**Wickhurst Green
Broadbridge
Heath**

Transport Assessment Addendum

29 October 2025

**STAGE 1
ROAD SAFETY AUDIT REPORT**

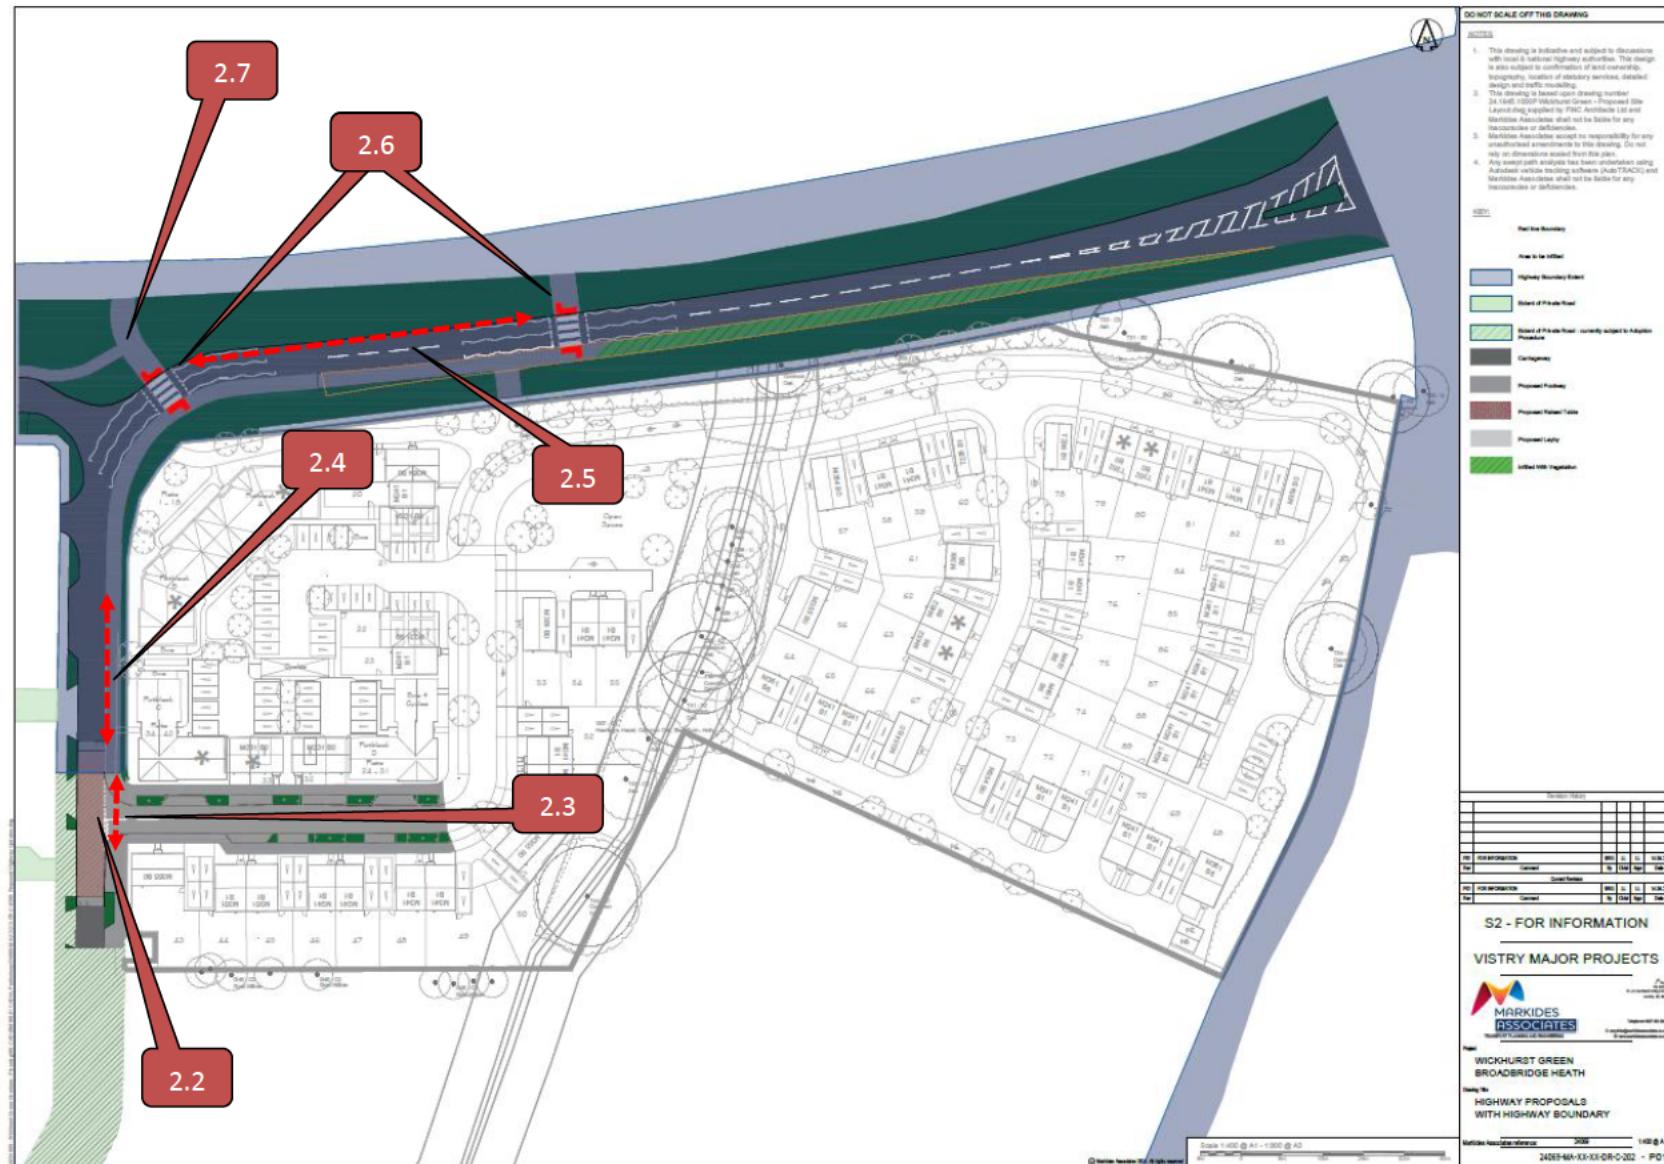
It would be more appropriate to provide a single zebra crossing facility across Broadbridge Way at a location where visibility splays to and from the crossing are not compromised. The crossing facility should be amended to provide a segregation between pedestrians and cyclists.

The proposals seek to provide a short section of footway on the northern side of Broadbridge Way to connect to the proposed shared use facility leading up to the zebra crossing at Sargent Way/Broadbridge Way junction. However, no details relating to the provision of corduroy tactile paving associated signs informing non-motorised users of the shared use facility may lead to a greater risk of collisions between non-motorised users.

Ensure that corduroy tactile paving associated signs informing non-motorised users of the change from a footway to a shared use facility are provided.
